STATE OF MAINE
 DEPARTMENT OF TRANSPORTATION
 16 STATE HOUSE STATION
 AUGUSTA, MAINE
 04333-0016

May 8, 2009
 Subject: **Bar Harbor & Trenton**
 Federal Project No's. STP-1279(700)X,
 STP-1133(500)X & STP-1133(710)X
 State Pin No's. 012797.00, 011335.00 &
 011337.10
Amendment No. 1

Make the following changes to the Bid Documents:

BAR HARBOR
 ROUTE 3
 TYPICAL SECTIONS

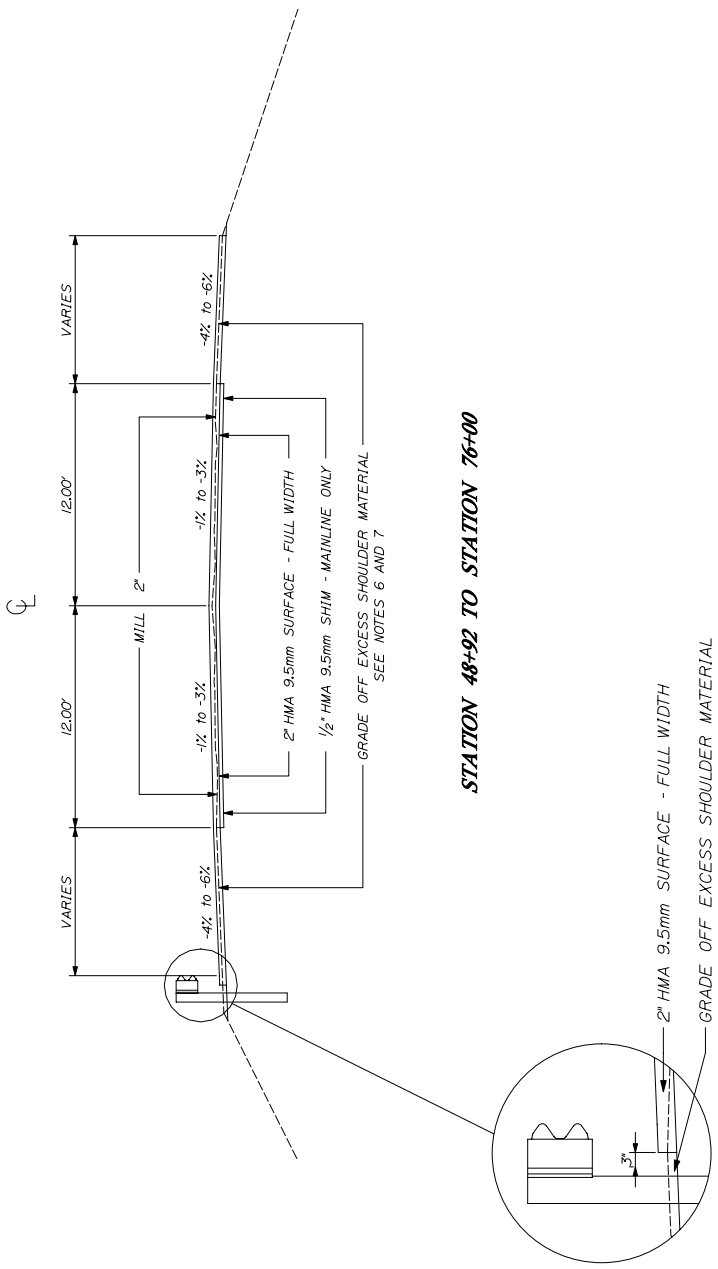
In the Bid Book, after page 33, **INSERT** the attached "TYPICAL SECTIONS" for "BAR HARBOR, ROUTE 3", 1 page undated.

**2" MILL & 1/2" HOT MIX ASPHALT SHIM - MAINLINE ONLY
 WITH 2" HOT MIX ASPHALT OVERLAY - FULL WIDTH**

STATION 48+92 TO STATION 76+00

PROJECT STRIPING

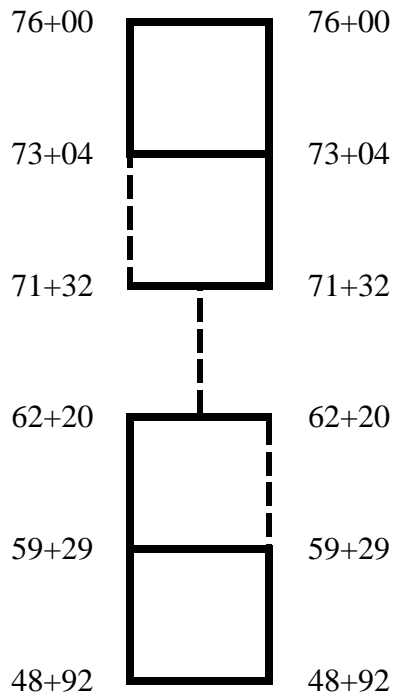
In the Bid Book, after "PROJECT STATIONING" (Bar Harbor), **INSERT** the attached "PROJECT STRIPING" (Bar Harbor), 1 page undated.
